PLANNING COMMISSION CONDITIONAL USE SITE PLAN SITE PLAN REVIEW SHEET

CASE NUMBER: SPC-2024-0259C **PC COMMISSION DATE:** February 25, 2025

PROJECT NAME: CIP - Rosewood-Zaragosa Neighborhood Center Walkway

Site Plan Application – Master Comment Report

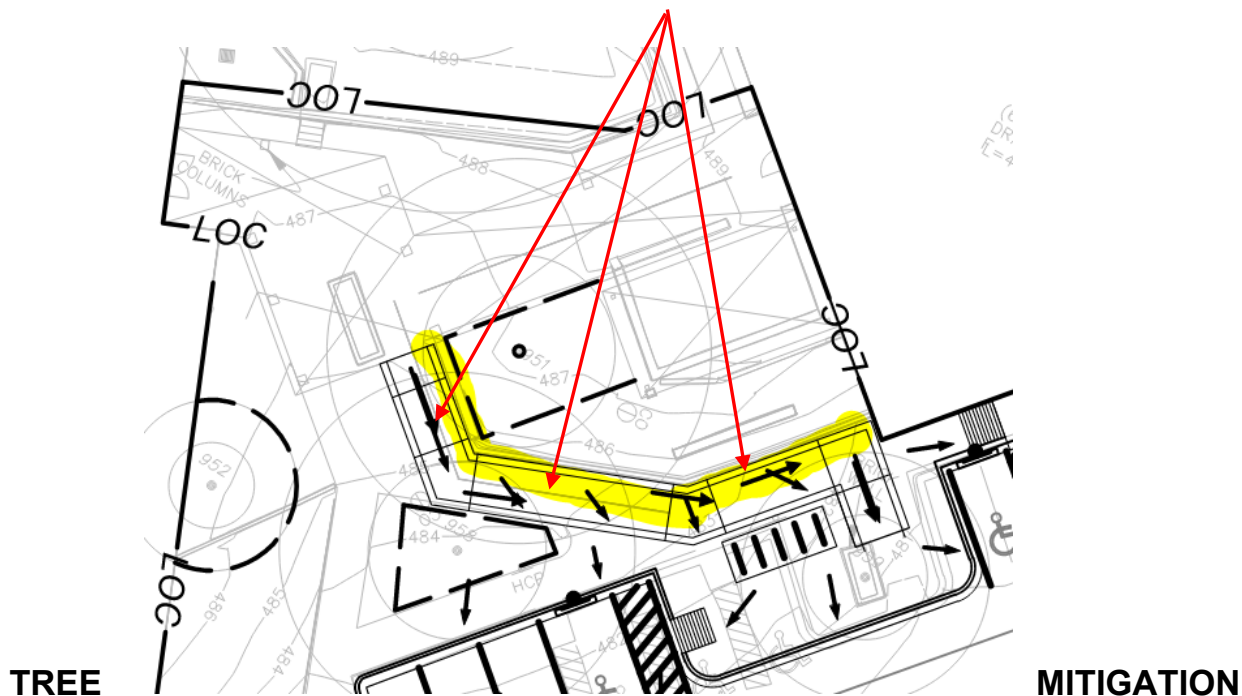
Please show tree fencing / protection on all regulated trees (8" in diameter or greater) to be preserved within or adjacent to the limits of construction (*ref: Tree # 950, 956, 953-955, and 958*).

1. If possible, extend all tree protection fencing to the full extent of the critical root zone (CRZ). If fencing cannot be installed around the full CRZ:
 - (a) Place the fencing at the Half CRZ and add 8" of hardwood mulch from the Half CRZ to the full CRZ.
 - (b) Provide call-outs stating: "2x4x6 or greater size lumber shall be strapped vertically to the tree and 8" of hardwood mulch shall be applied within the Full CRZ." Per standard detail 610S-4

U1: Comment cleared.

EROSION & SEDIMENTATION CONTROL PLAN - OVERALL

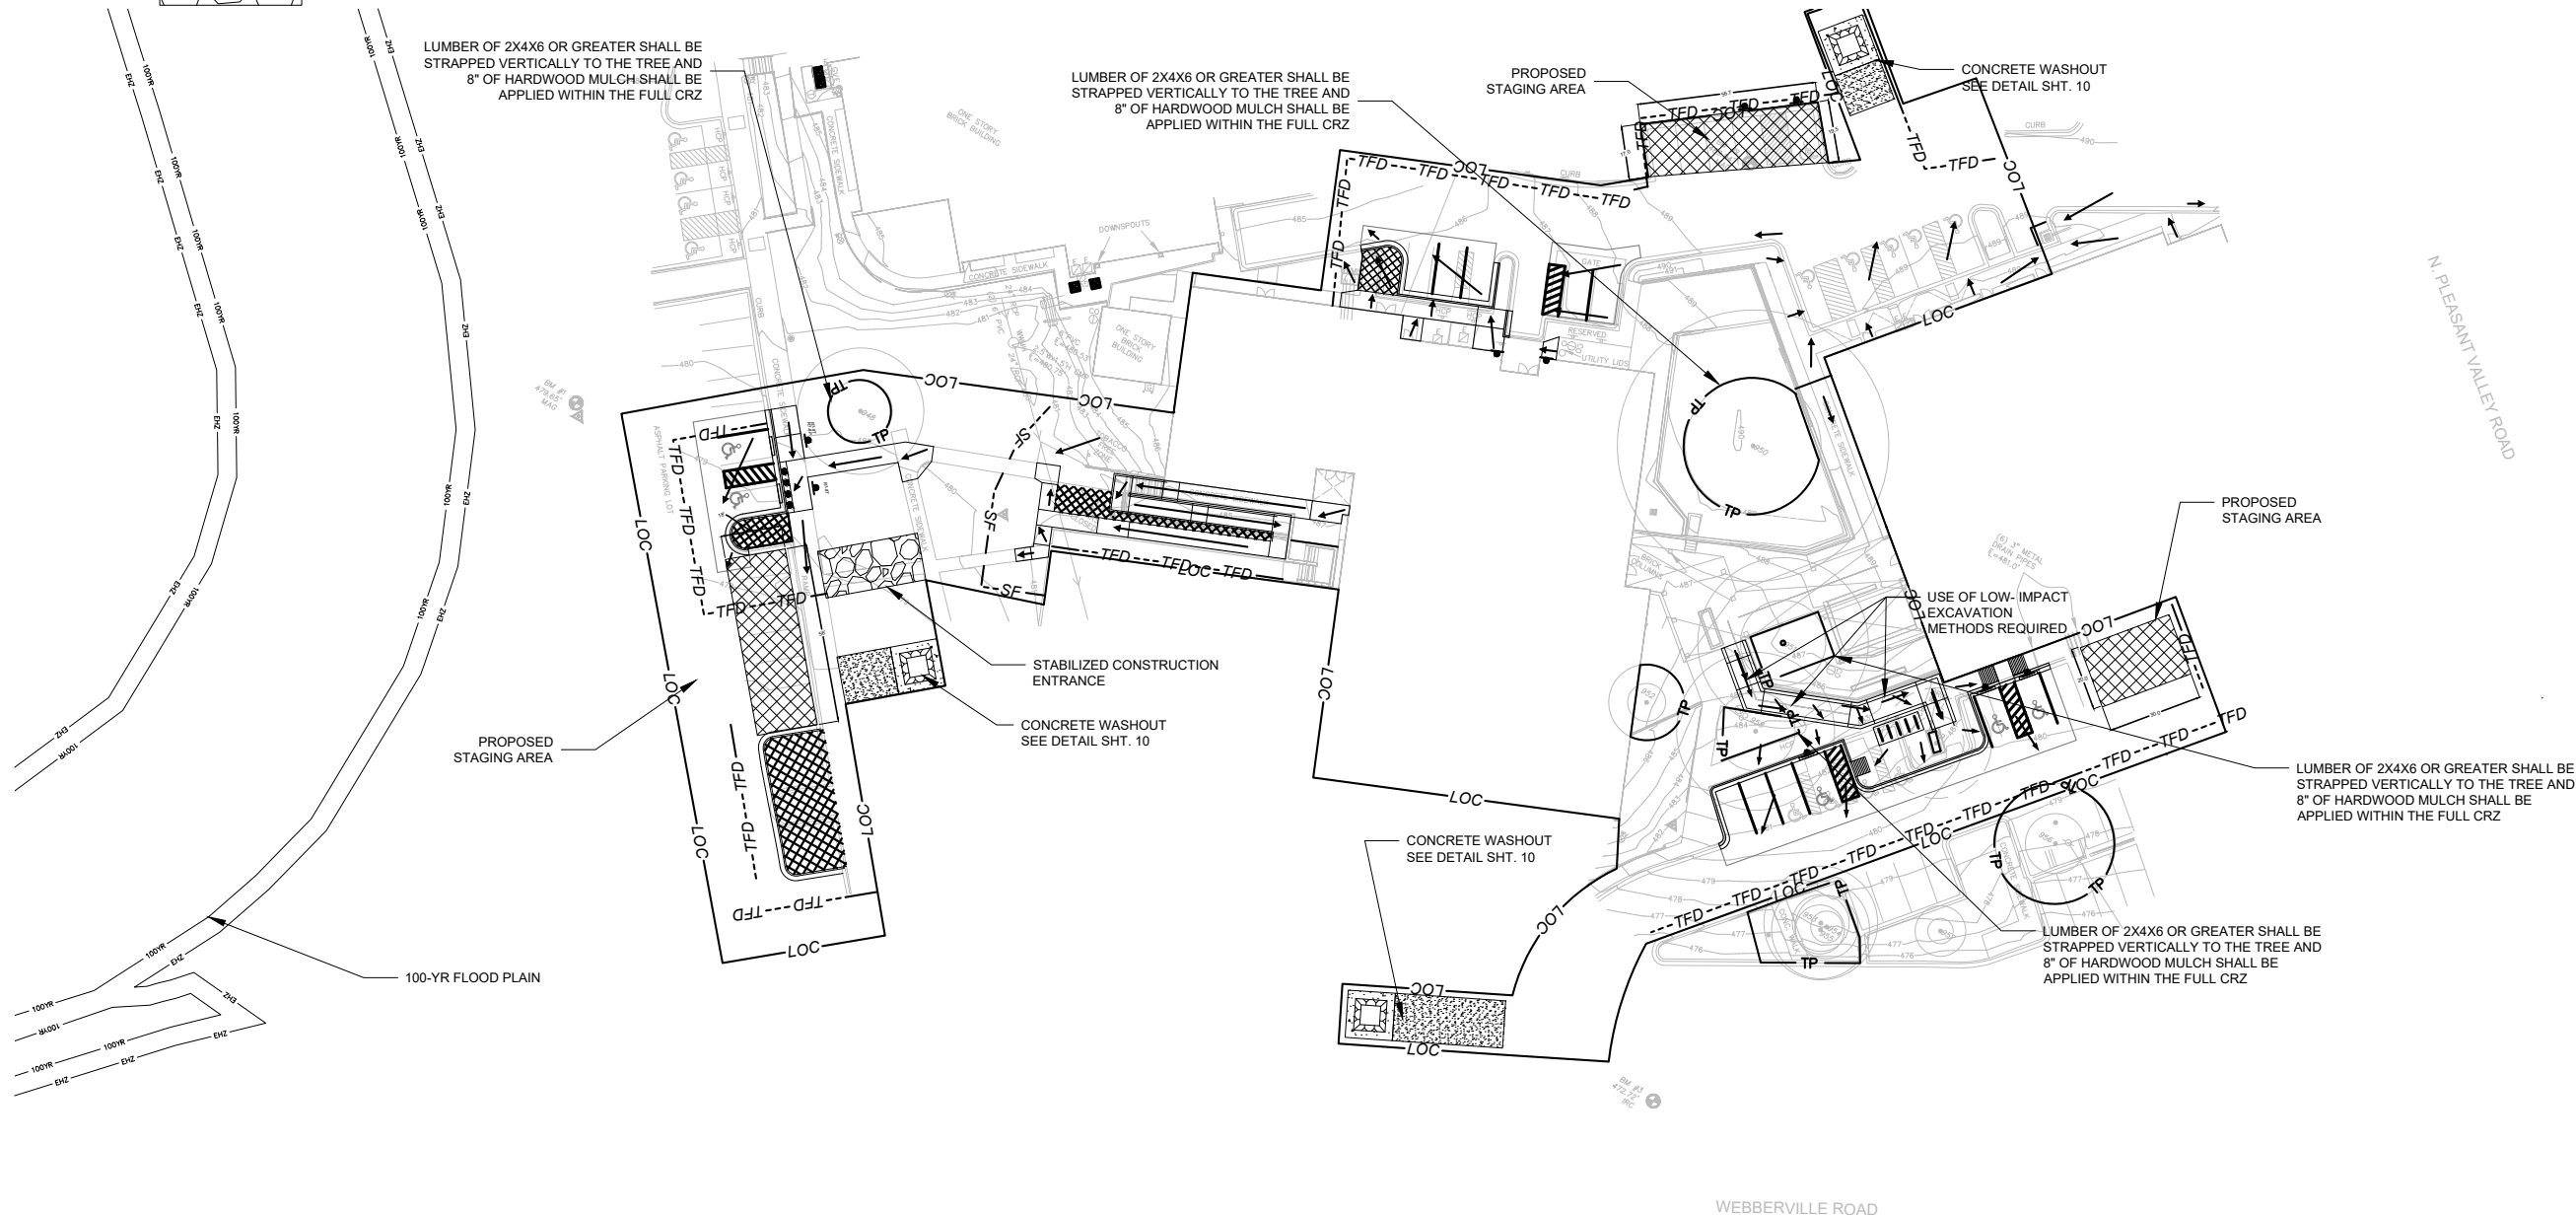
- U0: Add the following notes to all ESC sheets:
“If disturbed area is not to be worked for more than 14 days, disturbed area needs to be stabilized by revegetation, mulch, tarp, or revegetation matting. [ECM 1.4.4.B.3, Section 5.]

- U0: Surface water should be prevented from entering into the LOC from offsite upslope areas. Provided that it won't flood other property, add silt fence along the entire upslope LOC boundary to prevent surface water from draining into the LOC. [ECM 1.4.4.B.2]

U0: Existing Impacts (Ref: Tree # 951): Proposed impacts in the Half or Quarter CRZ are allowed within the footprint of existing impacts if they do not exceed the depth or width of those impacts. On the plan set, please provide a **callout** showing the location (below) where the use of low-impact excavation methods, such as hand digging, compressed air will be required during the retaining wall replacement to prevent damage to significant roots that are 1 ½ inches in diameter or greater.

LUMBER OF 2X4X6 OR GREATER SHALL BE STRAPPED VERTICALLY TO THE TREE AND 8" OF HARDWOOD MULCH SHALL BE APPLIED WITHIN THE FULL CRZ

7. FOR WORK ADJACENT TO TREE #951 CONTRACTOR SHALL USE LOW IMPACT EXCAVATION METHODS FOR RAMP AND RETAINING WALL CONSTRUCTION TO PREVENT DAMAGE TO SIGNIFICANT ROOTS THAT ARE 1 1/2" IN DIAMETER OR GREATER.
